WAIVER REQUEST FORM

WORCESTER HEALTH CENTER, 470 PLEASANT STREET, WORCESTER, MA

1.A: FOUND AT: _____ A1A Guidelines 2006, Section 3.7 - 5.2.1.1 (1)
(Regulation/Requirement Citation)

PLANNED PARENTHOOD WORCESTER HEALTH CENTER	CORRIDOR WIDTH WAIVER - Section 3.7 - 5.2.1.1 (1)	
		Project number	2007-02 SK W-10
		Date	FEBRUARY 15, 2008 Scale 1/16" = 1'-0"

1 MINIMUM PUBLIC CORRIDOR WIDTH
 1/16" = 1'-0"

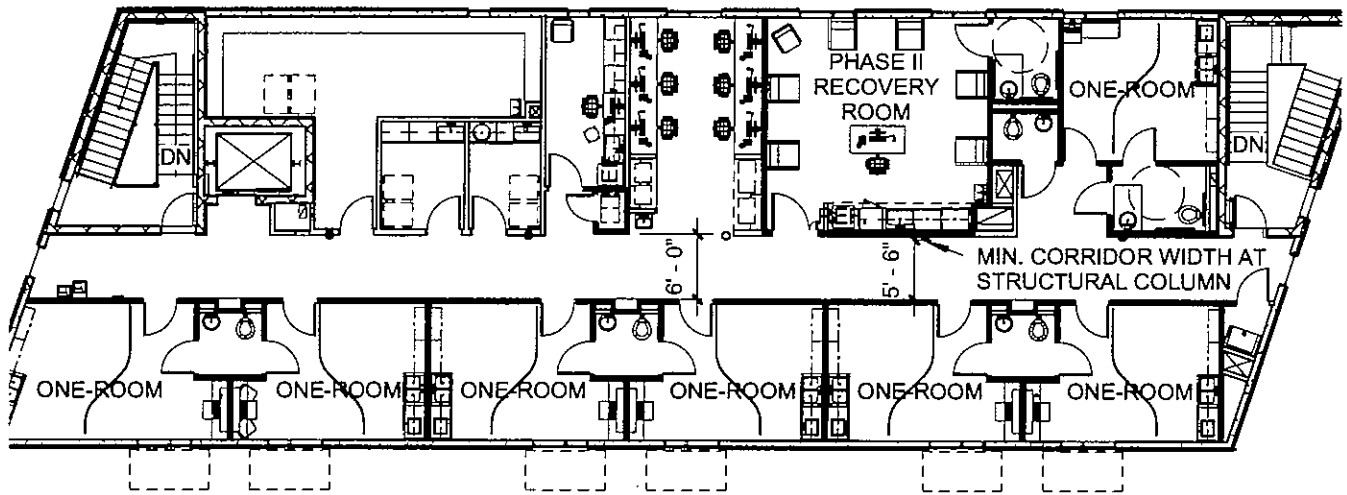
There are no corridors where patients are transported on stretchers or beds. The remainder of the corridors meets or exceeds the minimum 5 foot width.

Functionally, PPLM is an outpatient exam and treatment facility, but is being reviewed to comply with outpatient surgery facilities requirements. Corridors wider than necessary for clinical protocols would cause undue hardship relative to similar women's health care centers offering comparable services approved under former guidelines.

Corridor width of 5' is adequate for movement of patients and staff throughout the facility, including transport of a patient in a wheelchair. Because we do not transport patients on stretchers, a wider corridor is unnecessary.

Evaluated by: [Signature] 09/04/08 [X] Approved [] Approved w/Conditions [] Denied

Reviewed by: [Signature] 9/9/08 [X] Approved [] Approved w/Conditions [] Denied
